Sunnyside Cogeneration Associates

RE: Sunnyside Refuse and Slurry C/007/0035
Permit Amendment – East Haul Road

Title: East Haul Road

Extension of Haul Road E to the east. Adjustment of other road designations

SHEET
5-2

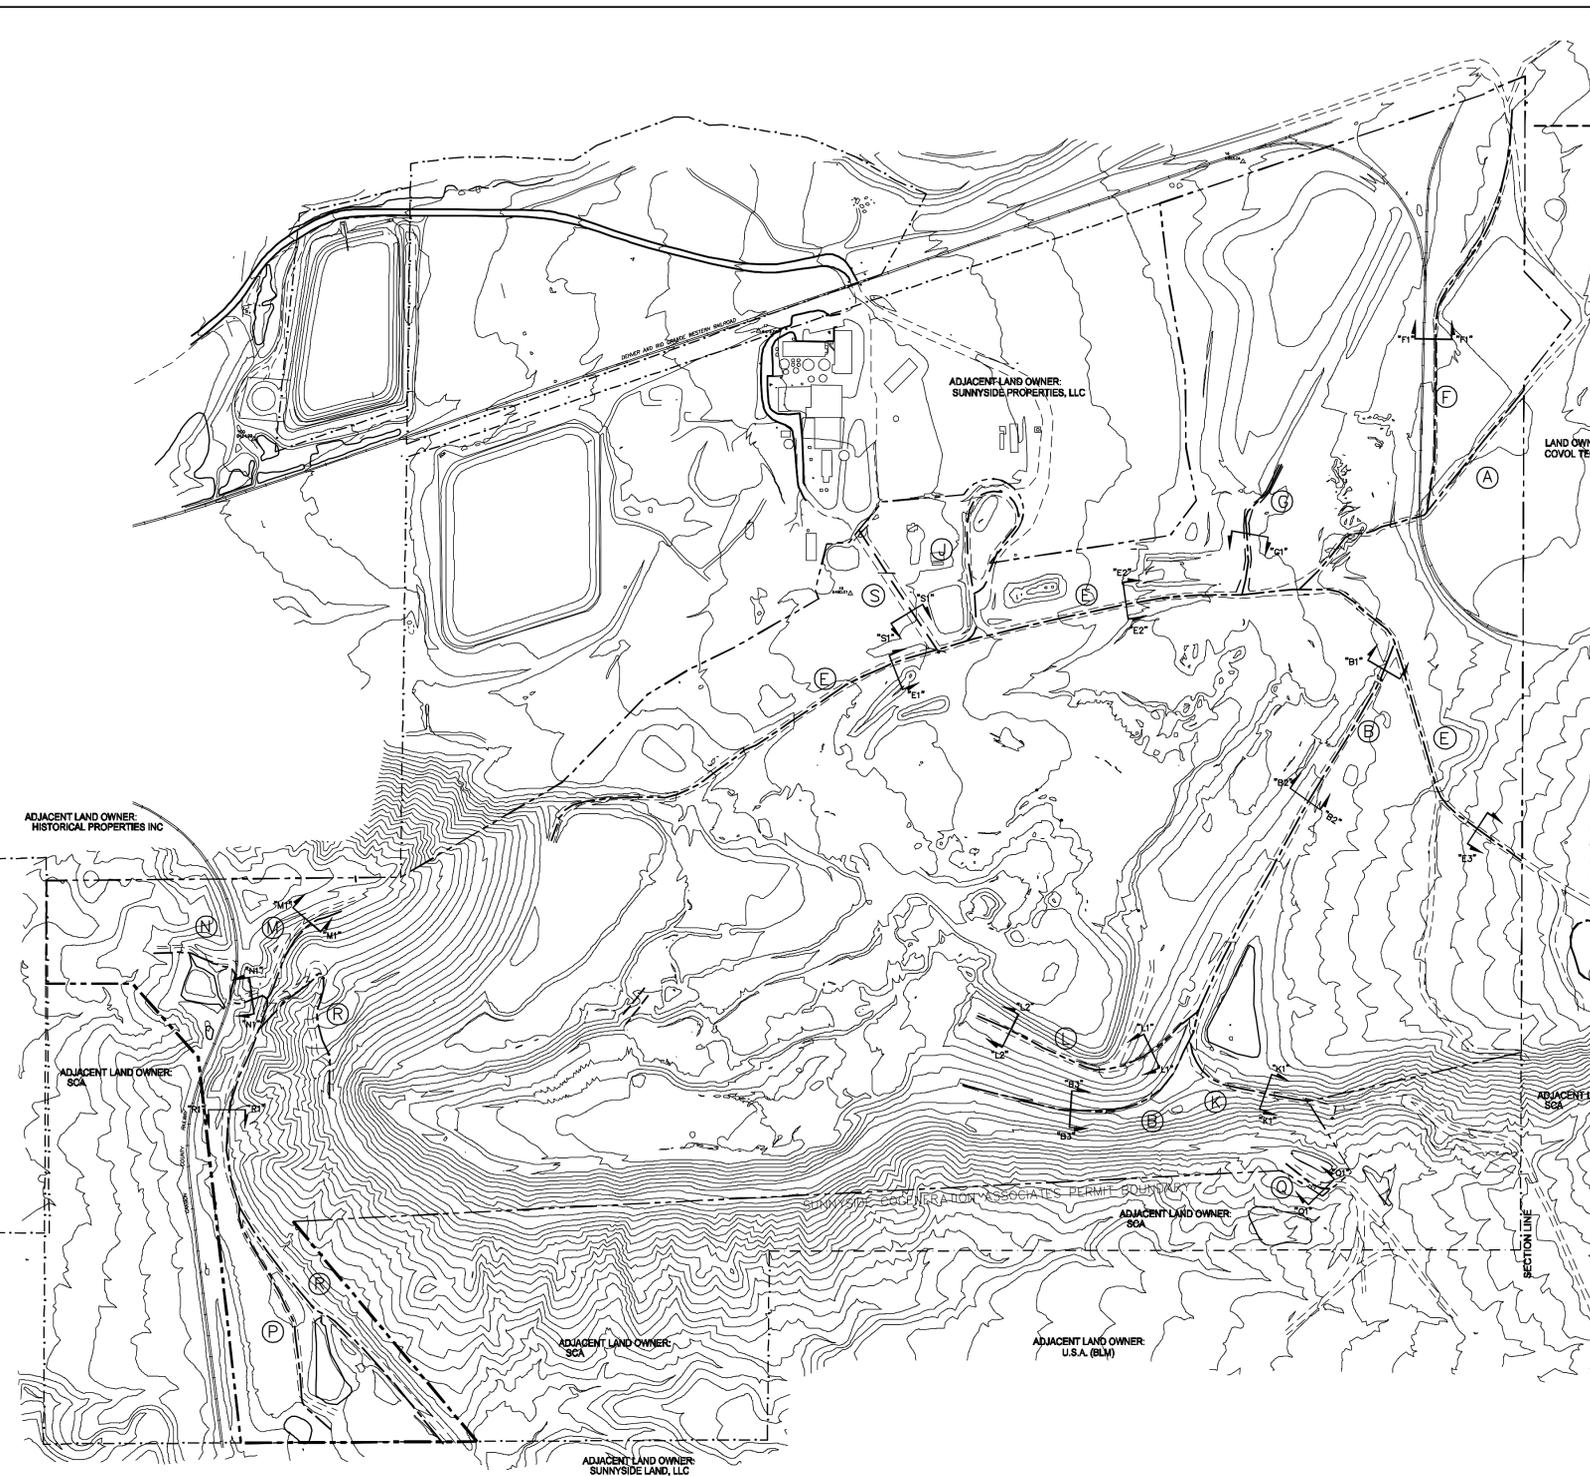
Road E is a primary haul road and has been extended east along an old existing disturbed road. Grading and increased maintenance will occur during periods of hauling. A portion of the existing Road B was included into Road E, resulting in a shortening of Road B.

Road T was previously approved to cross the refuse pile but did not get constructed. SCA has determined that it will not need to build Road T and it has been removed from the permit.

Roads surrounding the Excess Spoil Disposal Area #2 Phase 1 were reclaimed together with the Disposal Area reclamation. They have been removed from the permit.

REV	DATE	DESCRIPTION	BY	APP'D
1	8/16	SHORTEN ROAD B AND EXTEND ROAD E REMOVE RD T	AH	
2	1/16	ROAD RECLAMATION UPDATES	AH	
3	7/15	WEST PASTURE AND REFUSE PILE ACCESS ROADS	AH	
4	11/10	BOUNDARY AND TOPO UPDATE	AH	
5	2/07	CHANGE IN ROAD H	AH	
6	9/02	2002 PERMIT RENEWAL	PAM

Sunnyside Cogeneration Associates
 ROAD PLAN AND PROFILE
 ROADS "A" & "E"

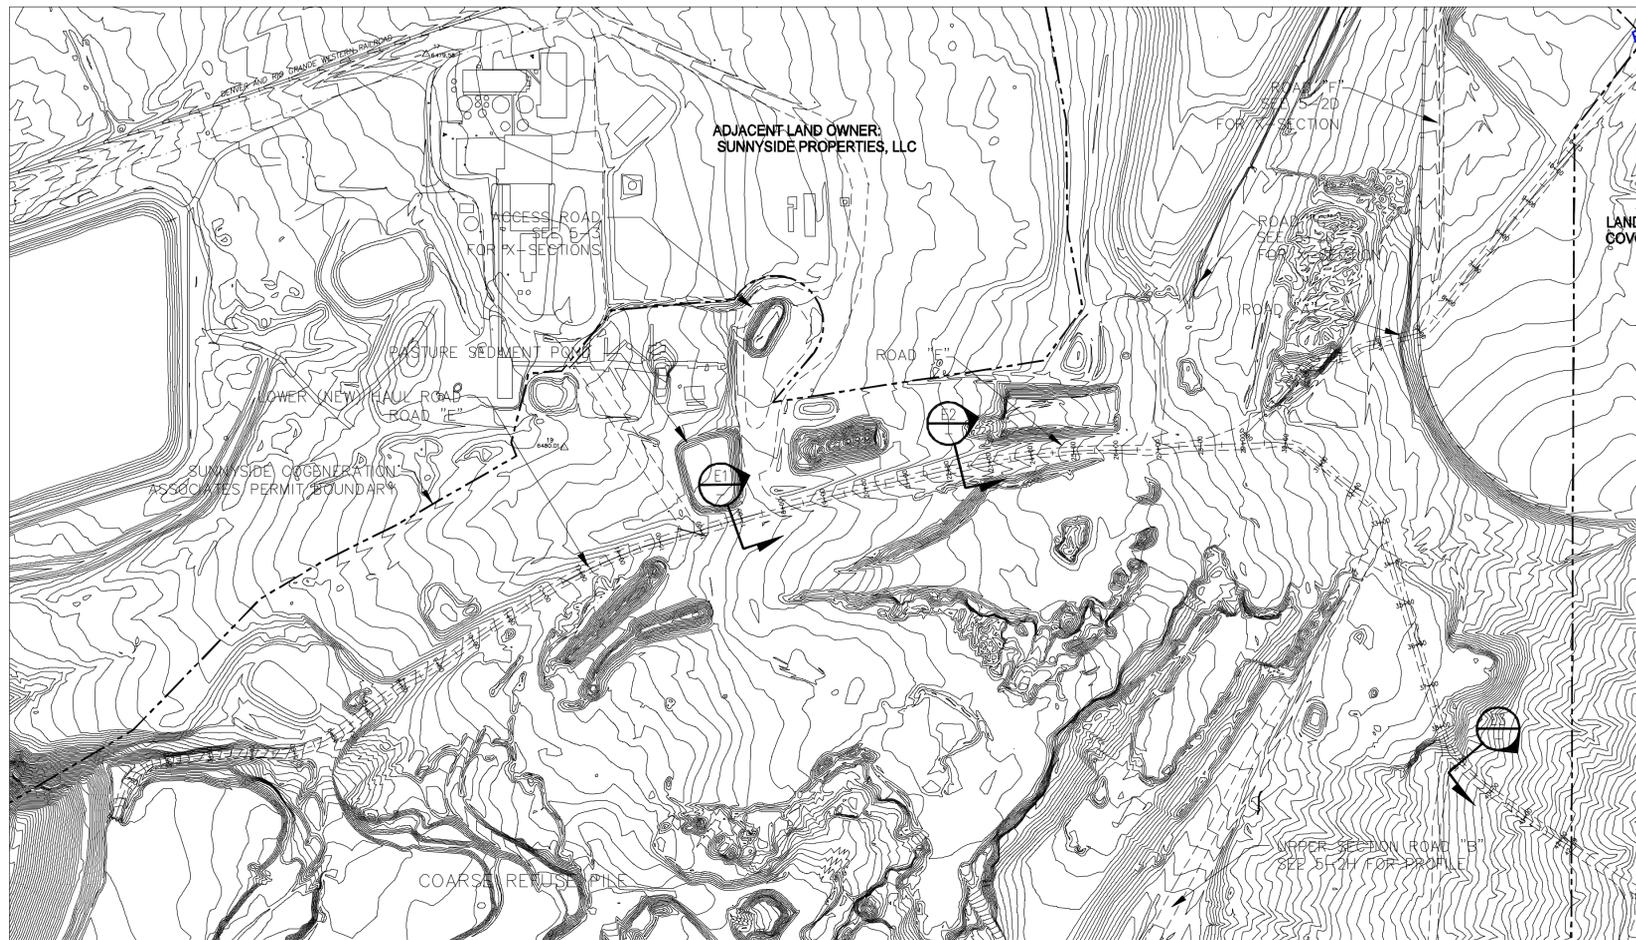
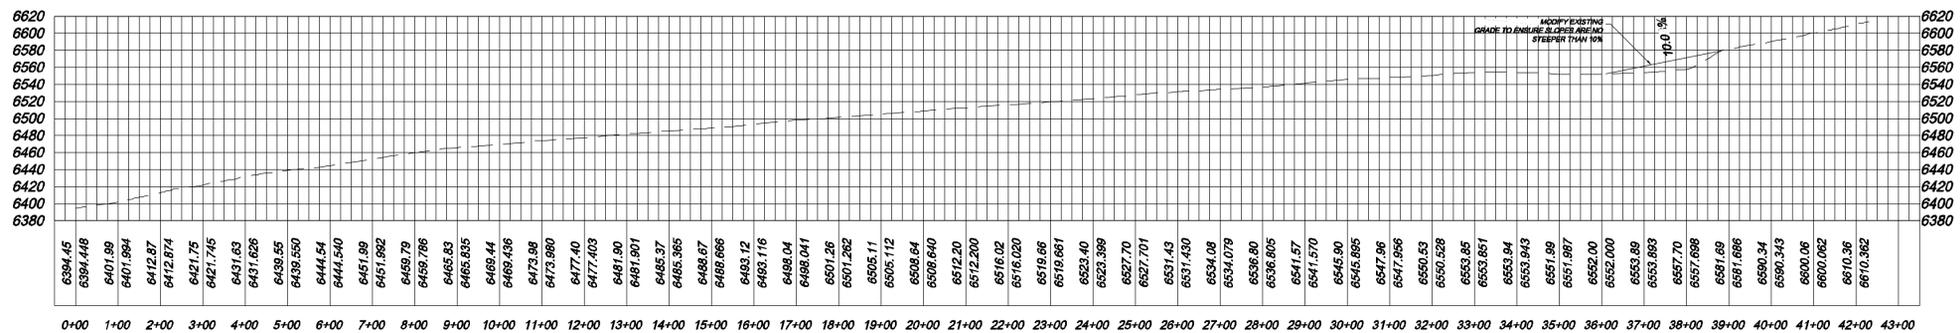
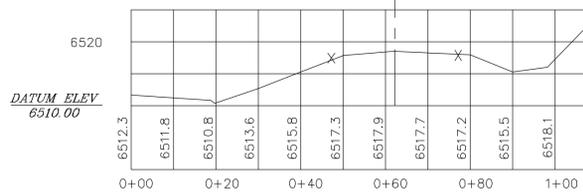
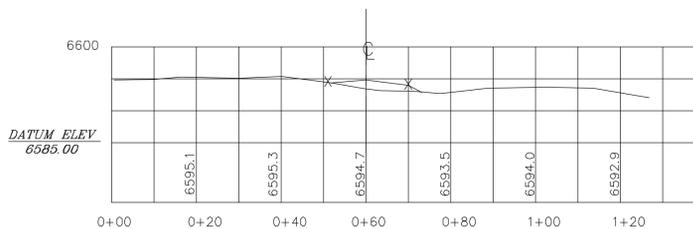
REV	DATE	DESCRIPTION	BY	APP'D
△	7/16	EXTEND ROAD E	AH	
△	11/10	BOUNDARY AND TOPO UPDATES	AH	
△	9/02	2002 PERMIT RENEWAL	PAM	
△	9/97	PERMIT RENEWAL-UPDATE	CAC	
△	2/94	REVISED BOUNDARY	AH	
△	11/93	NEW X-SECTIONS	AH

Sunnyside Cogeneration Associates
PLAN AND PROFILE
ROADS "F" & "G"

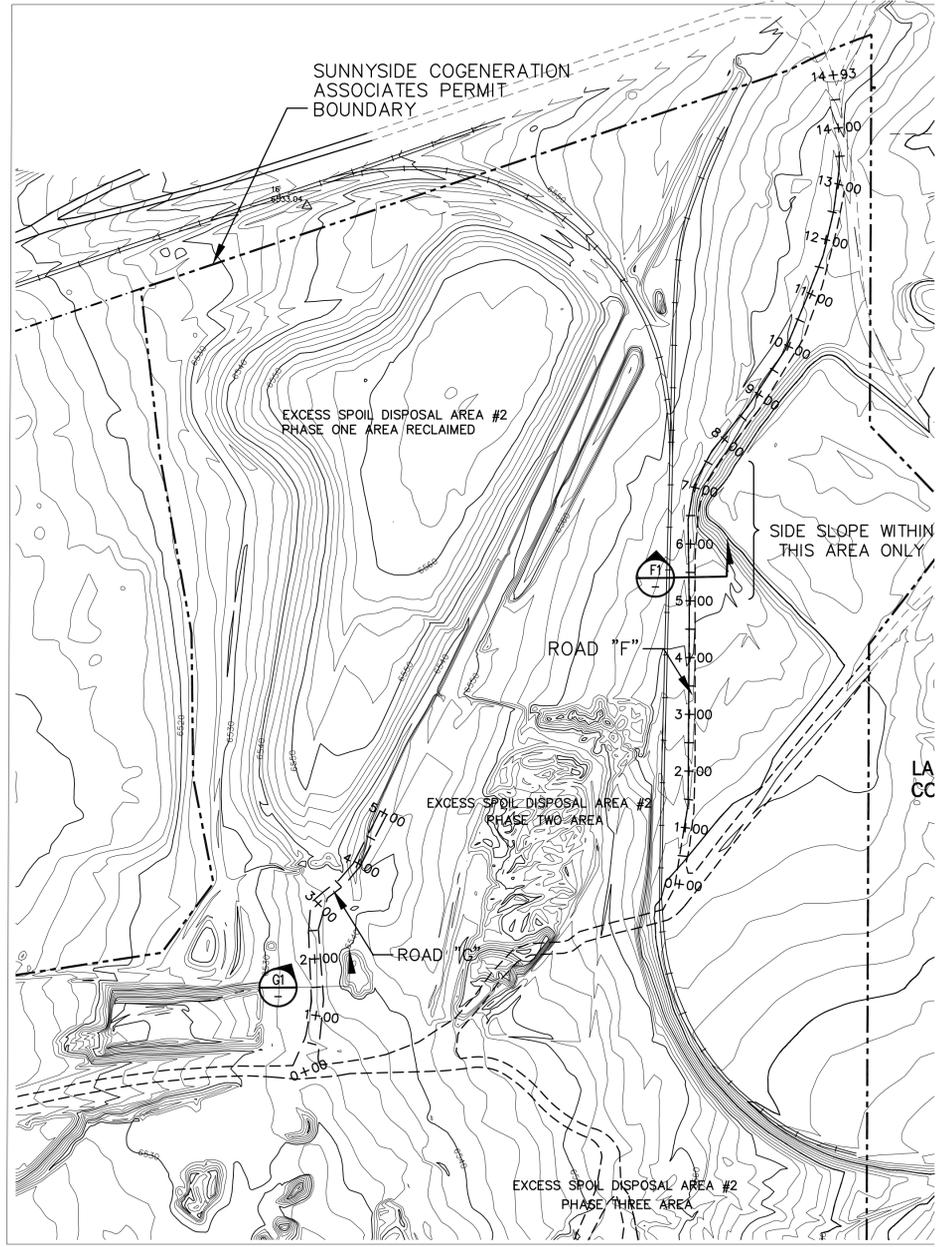
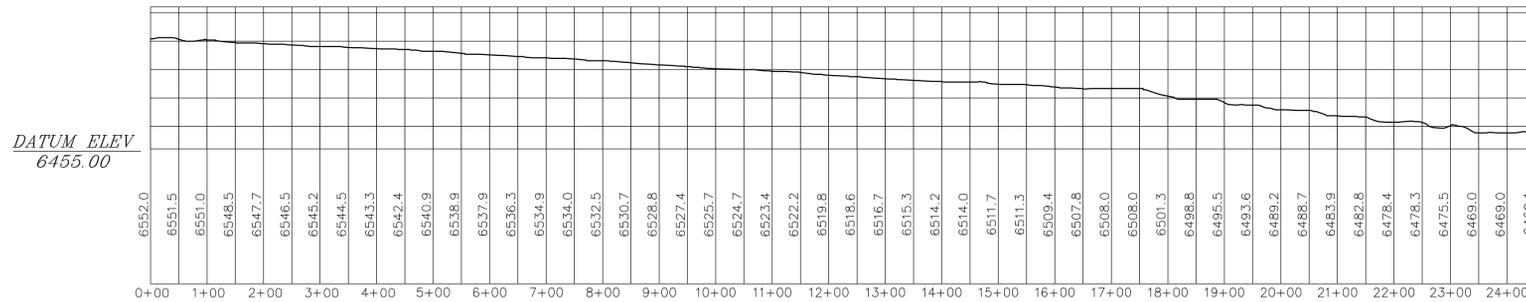
REV	DATE	DESCRIPTION	BY	APP'D
△				
△	1/16	ROAD RECLAMATION UPDATES		AH
△	11/10	BOUNDARY AND TOPO UPDATES		AH
△	9/02	2002 PERMIT RENEWAL		PAM
△	9/97	PERMIT RENEWAL - UPDATE		CAC
△	2/94	REVISED SECTIONS		AH

Sunnyside Cogeneration Associates
 PLAN AND PROFILES
 ROAD "S"

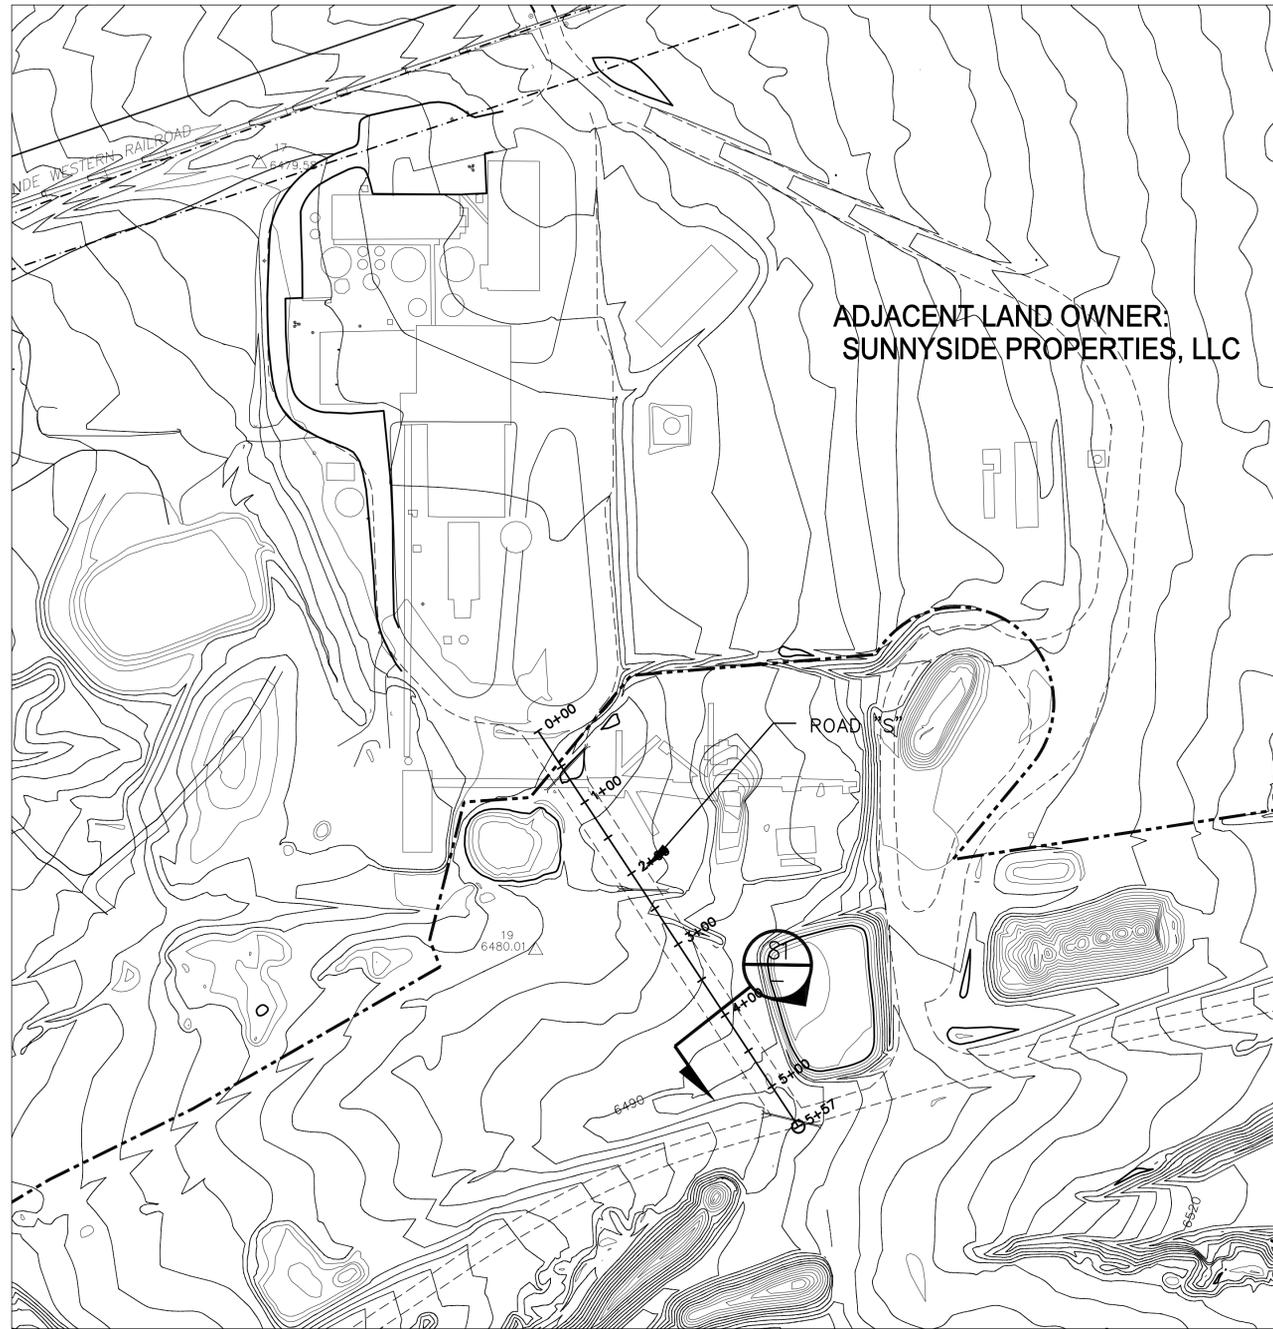
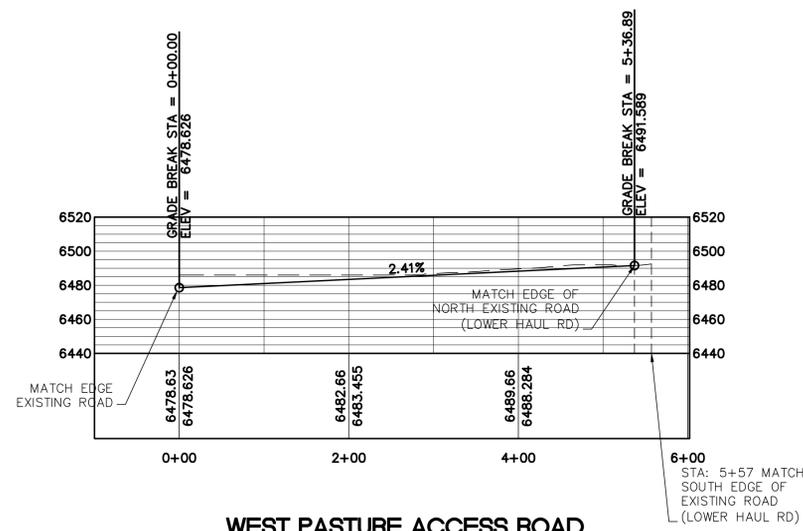
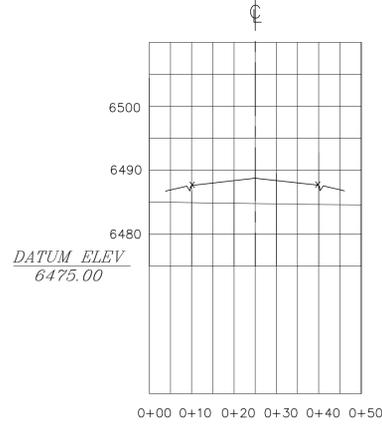
△			
△			
△			
△			
△			
△	8/16	REMOVE ROAD T	AH
REV	DATE	DESCRIPTION	BY
